SERVICE LETTER 191

FIRE BOSS WATER SCOOP SWITCH REPLACEMENT

Aircraft Makes/Model(s):	Float Model(s):	Compliance: As required	By: MAB
AT-802 & AT-802A	10000A	Part Number: 1009904	Approved: SDW
		Date: 9/26/2019	Revision: C

DETAIL A

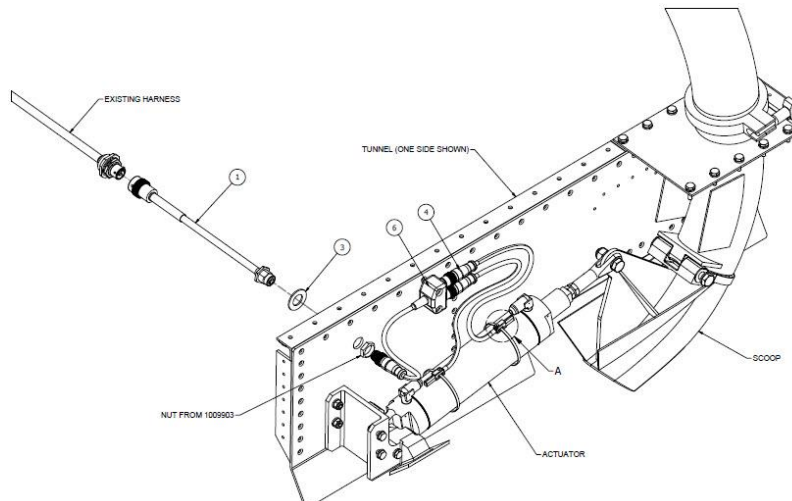
10. Ensure connector end and internal area remain free of sealant.
11. Remove left hand screws from Inductive Magnet Sensors (S4685792). Mount switches on scoop hydraulic actuator using ASB-6 Straps (M6965106) and Cord Sets (S693351). See Detail A.
